# **Lilac Hills Ranch**

**Roundabout Peer Review by Reid Middleton**

**Roundabout Peer Review  
Exhibit of Findings  
October 2013**

Project Title:	W Lilac Rd Roundabouts	Design Phase (%):	Conceptual
Owner:	Accretive Investments, Inc.	Date:	October 25, 2013

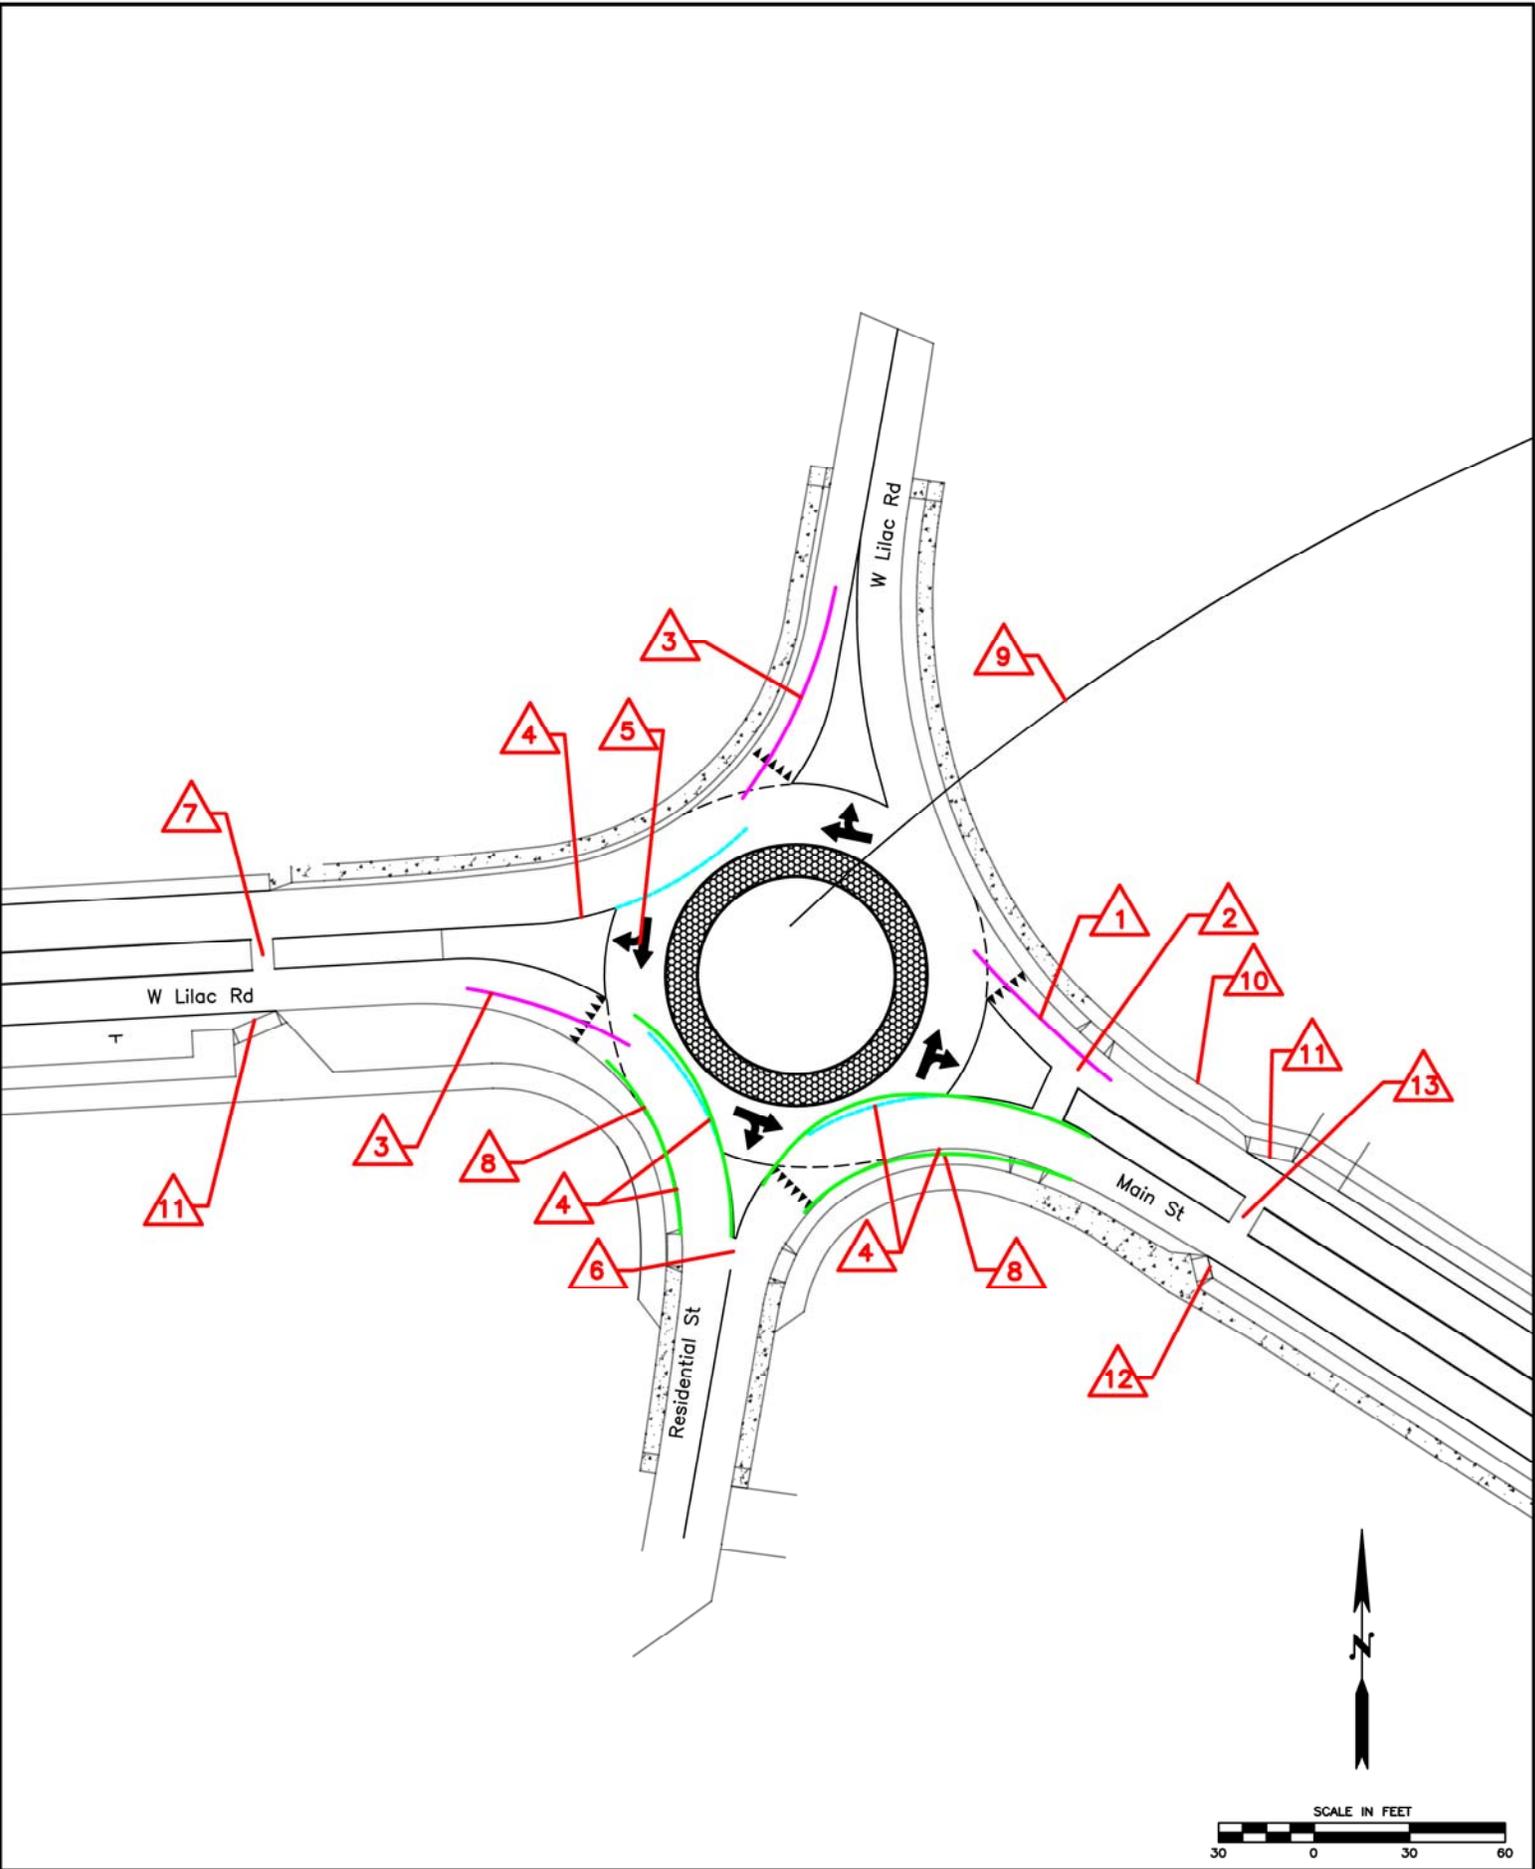
Peer Review RB 1	A four-leg conceptual roundabout with the existing W Lilac Rd configuration was reviewed. The following item nos. 1-13 correspond to the triangular callouts on Figure 1.

Topic/ Reference	Comment
Item 1 (Figure 1)	The geometry for the approach from Main St does not slow vehicles as they enter the roundabout. Vehicles can enter the roundabout at a speed greater than 40mph while the conflicting traffic would be traveling approximately 15mph. Speeds this fast negate the innate safety benefits associated with single lane roundabouts. There will be an increase in failure to yield, increasing the potential for collisions. In addition, these potential collisions will result in severe damage due to the high speed differentials. A speed differential 6-7mph in conflicting paths is recommended at this location. In addition, entering speeds should be approximately 20-22mph.

Item 2 (Figure 1)	The geometry for the approach from Main St does nothing to slow vehicles down prior to the crosswalk location. The safety of pedestrian, bicycles, and equestrian users are dependent on slow vehicle speeds, controlled by the geometry of the roundabout. In addition, the commuter bicyclists will want to merge with vehicle traffic to negotiate the roundabout which is easier and safer when speeds are kept around 20-22mph.

Item 3 (Figure 1)	The geometry for the approaches from W Lilac Rd (both the west and north leg) do not slow vehicles sufficiently. Vehicles can enter the roundabout at 25mph while an entering speed of 20-22mph is more appropriate for a roundabout. See Item 2.

Item 4 (Figure 1)	The exit onto Main St, Residential St and W Lilac Rd (west leg) is not a natural path. Vehicles will need to brake to negotiate the exit safely, contrary to driver expectation. In addition, the splitter island does not guide circulating vehicles out of the roundabout in a path that is natural (see cyan line). The radius of this splitter island stripe should be tangent with the central truck apron curb. The potential for curb strikes on these exits is high and the capacity will be decreased with this type of design.

Item 5 (Figure 1)	Pavement marking arrows in circulating lane for a single lane roundabout are not recommended.
Item 6 (Figure 1)	The splitter island is too short on the Residential St. A minimum splitter island length of 50ft is recommended for this location. In addition, the pedestrian refuge is compromised on this leg. The pedestrian refuge island is an important safety feature at this location due to the trail connection and pedestrian connectivity.

Item 7 (Figure 1)	The bicycle crossing on W Lilac Rd (west leg) is located too far from the roundabout to get any safety benefits associated with vehicles slowing to negotiate the intersection. Ideally these crossings should be located one car length from the circulating roadway of the roundabout.

Item 8 (Figure 1)	The design vehicle (WB-50) does not seem to be accommodated on the exit to the Residential St and to Main St (see green lines depicting the tire tracks). A design vehicle should be able to negotiate the roundabout without having to put the tractor tires onto the truck apron (which is reserved for the trailer part of the truck). It is recommended that a WB-50 be able to negotiate this roundabout to ensure construction vehicles for the development will have adequate access.

Topic/ Reference	Comment
Item 9 (Figure 1)	It is not clear how this roundabout would accommodate the proposed IOD without major shifts in central island location or other approach alignments.

Item 10 (Figure 1)	The minimum recommended multiuse trail is 8ft. On Main St from the bike ramp to the pedestrian crosswalk, a minimum width of 8ft should be maintained.

Item 11 (Figure 1)	The bike ramp to the multiuse trail from W Lilac Rd and Main St is too wide. This may be mistaken as a driveway and entice vehicle traffic. In addition, RM does not recommend bicycle ramps oriented this way as less experienced bicyclists will swerve into travel lane to line themselves up with the ramp. See Appendix E for more explanation on Bicycle Treatment Facilities.

Item 12 (Figure 1)	The bicycle ramp exiting onto Main St is angled in a way that inexperienced bicyclists will be guided into the vehicle traffic. See Appendix E for more explanation on Bicycle Facilities.

Item 13 (Figure 1)	This location is not recommended as a bicycle crossing (see Item 7).
Peer Review RB 2	The conceptual layout of RB 2 was in the development stages of design. Therefore, the roundabout details were not reviewed, including the design of bicycle and pedestrian facilities. The following item nos. 14-21 correspond to the triangular callouts on Figure 2.

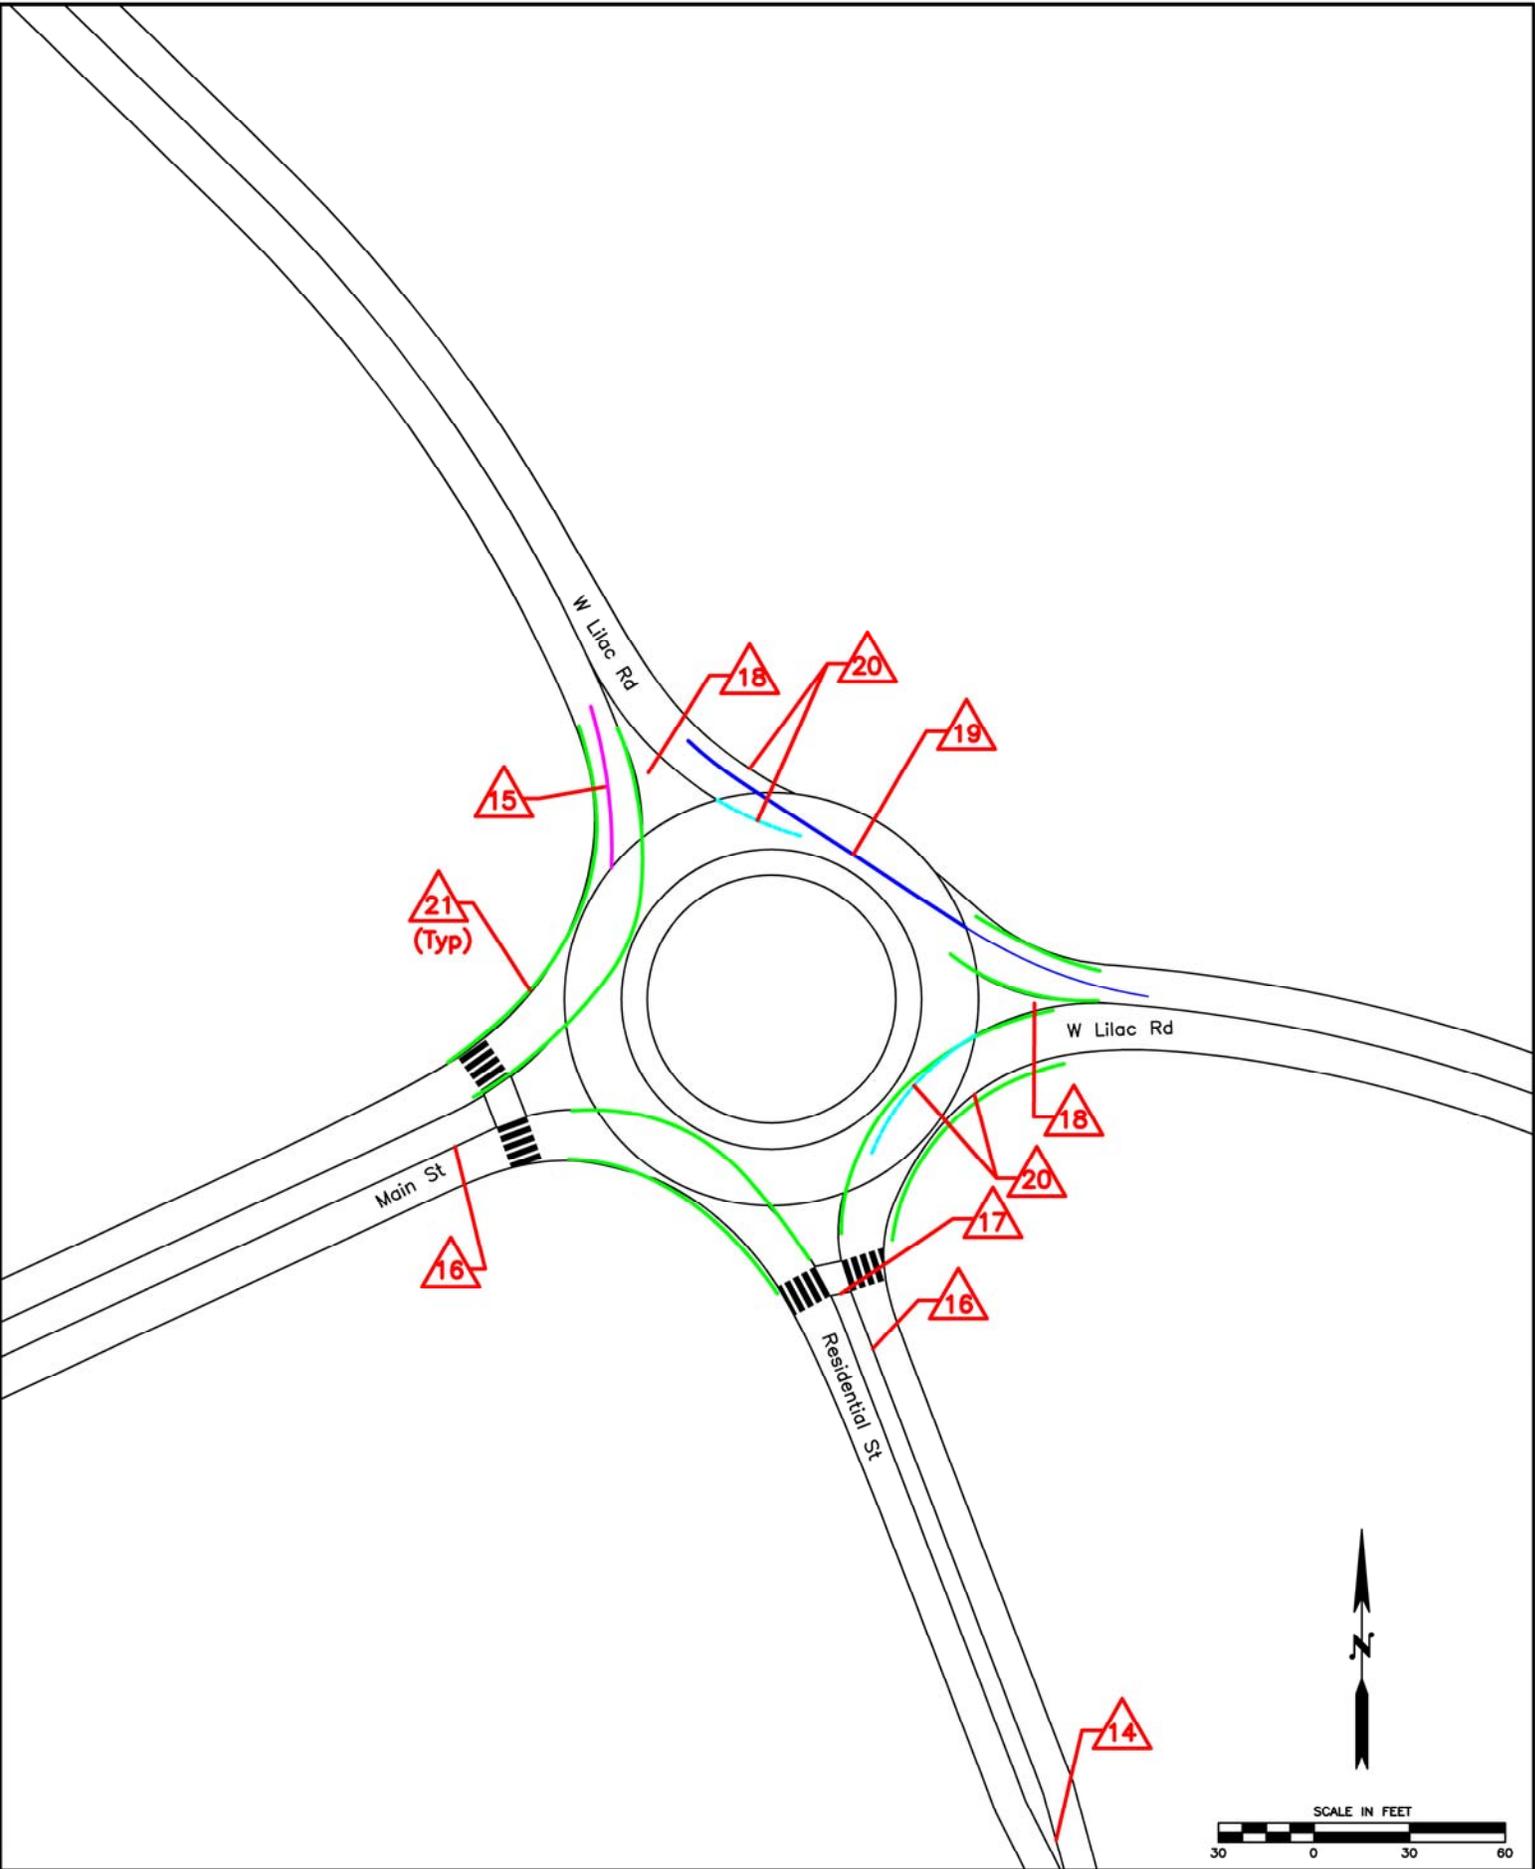
Item 14 (Figure 2)	The taper rate for the splitter island on the Residential St is abrupt for an approach speed of 30mph.
Item 15 (Figure 2)	The geometry for the approach from W Lilac Rd (north leg) does not slow vehicles sufficiently as they enter the roundabout. Vehicles can enter the roundabout at 25mph while an entering speed of 20-22mph is more appropriate for a roundabout. This will ensure the safety benefits and capacity predicted for this single lane roundabout are achieved.

Item 16 (Figure 2)	The geometry for the approach from Main St and the Residential St does nothing to slow vehicles down prior to the crosswalk location, which causes safety concerns.

Topic/ Reference	Comment
Item 17 (Figure 2)	The pedestrian refuge island on the Residential St may not meet current standards for a minimum distance of 6.0ft. This refuge does not provide adequate protection.

Item 18 (Figure 2)	The splitter islands are too short on W Lilac Rd (both the north and east legs). A minimum splitter island length is 50ft, however due to the higher speeds on this approach a longer splitter island is desirable (100-150ft).

Item 19 (Figure 2)	The right turn from westbound W Lilac Rd is an unnatural path. Drivers will straighten this path out (see difference between outside curb lines and the blue line). The straightened path creates a faster right turn that is appropriate at this location. In addition, the unused space is inefficient and will collect debris.

Item 20 (Figure 2)	All of the exits from this roundabout are designed with an unnatural path, however, it is more pronounced on the W Lilac Rd (north and east legs). Vehicles will need to brake to negotiate these exits safely, contrary to driver expectation. In addition, the splitter island does not guide circulating vehicles out of the roundabout in a path that is natural (see cyan line). The radius of this splitter island stripe should be tangent with the central truck apron curb. The potential for curb strikes on these exits is high and the capacity will be decreased with this type of design.

Item 21 (Figure 2)	The design vehicle (WB-50) does not seem to be accommodated on the exit to the Residential St and to Main St (see green lines depicting the tire tracks). A design vehicle should be able to negotiate the roundabout without having to put the tractor tires onto the truck apron (which is reserved for the trailer part of the truck). It is recommended that a WB-50 be able to negotiate this roundabout to ensure construction vehicles for the development will have adequate access.
RM Design RB 1 RB 1 (Alt A) RB 1 (Alt B)	RM designed a conceptual roundabout that addresses the above concerns of the first intersection. This layout, RB 1, is designed to accommodate the existing W Lilac Rd (north leg). The following item nos. 22-25 correspond to the circular callouts on Figure 3. The roundabout is versatile so that with minor modifications, it will accommodate the proposed IOD alignment rather than the existing W Lilac Rd (north leg). The location of the central island and three legs are the same in this roundabout, RB 1 (Alt A) as in RB 1. An accurate representation of the roundabout impacts, regardless of which alignment is built for that fourth leg, can be determined and quantified for the majority of the intersection. Item no. 26 corresponds to the circular callouts on Figure 4. Finally, in an effort to provide for both the W Lilac Rd (north leg) and proposed IOD alignment, a five-leg roundabout, RB 1 (Alt B) was designed. The following item nos. 27-29 correspond to the circular callouts on Figure 5. Appendix B contains all the corresponding back-up calculations for the horizontal geometrics of these RM conceptual roundabouts such as fastest paths, truck turning movements and sight distance requirements.

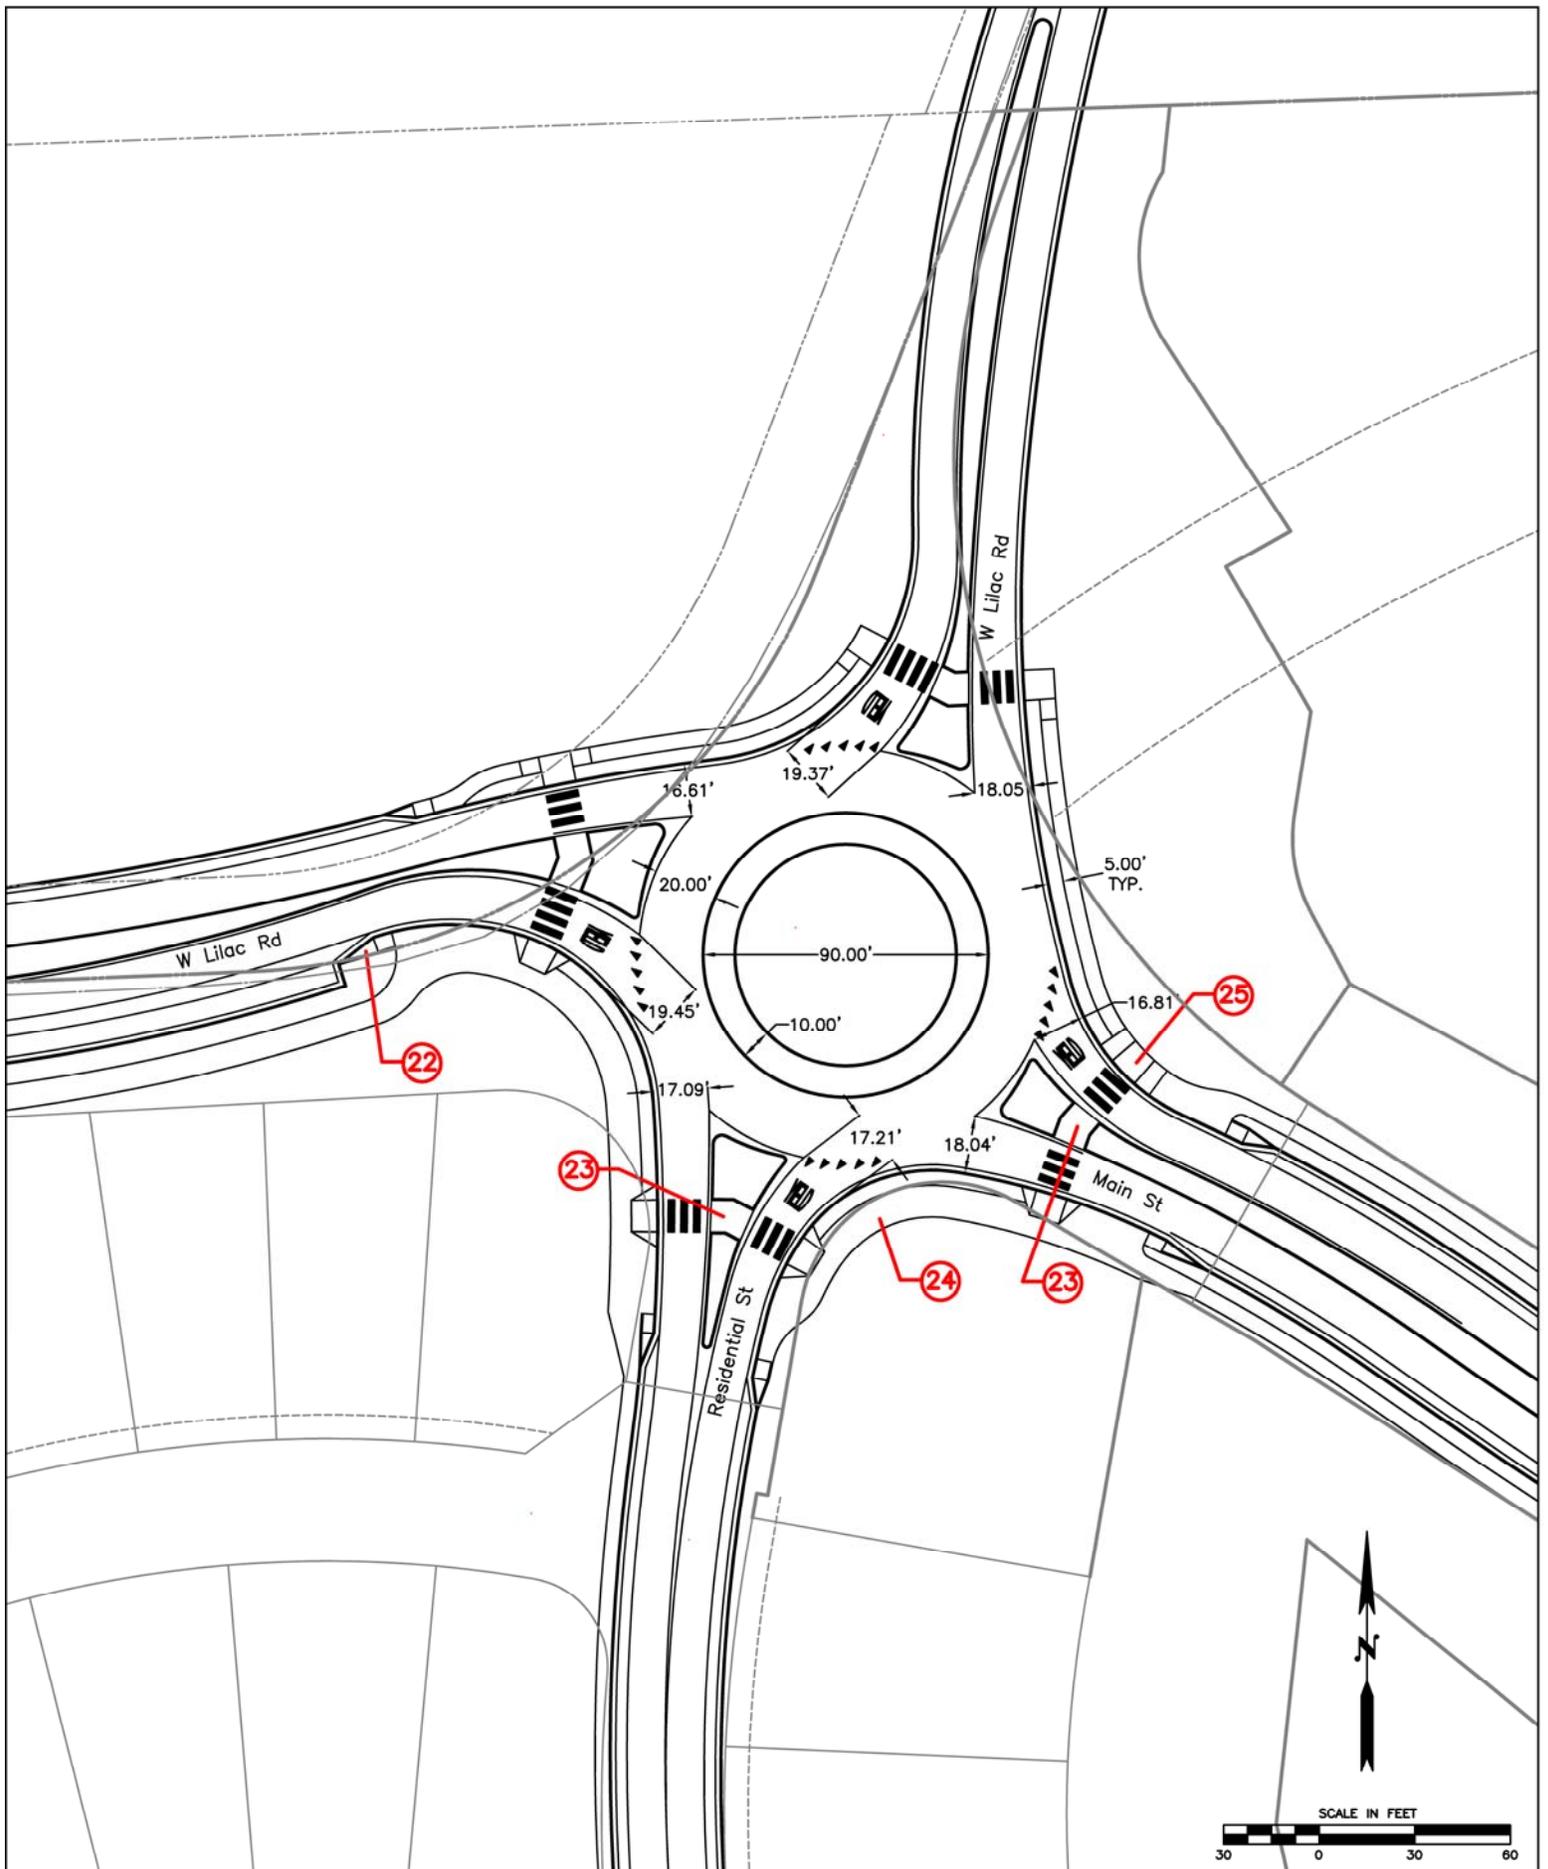
Topic/ Reference	Comment
Item 22 (Figure 3)	Bike ramps are detailed based on RM recommended design. The reasoning behind this type of design can be found in Appendix E.

Item 23 (Figure 3)	Pedestrian refuge islands were designed with equestrian users in mind – the width is a minimum of 10ft.
Item 24 (Figure 3)	Multiuse trail and landscaping buffer widths can be adjusted. (Multiuse trail minimum width is 8ft with 10ft being desirable).

Item 25 (Figure 3)	This type of ramp was used to indicate that all multiuse path users except bicyclists should use this pedestrian crossing and subsequent multiuse paths. The bike path continues around the north side of the roundabout and “bike only” pavement markings could be used. For bicycle users, the path around the north of the roundabout was designed to limit crosswalk exposure for those traveling from Main St to westbound W Lilac Rd (only one crossing versus three if they traverse using the southern multiuse path).
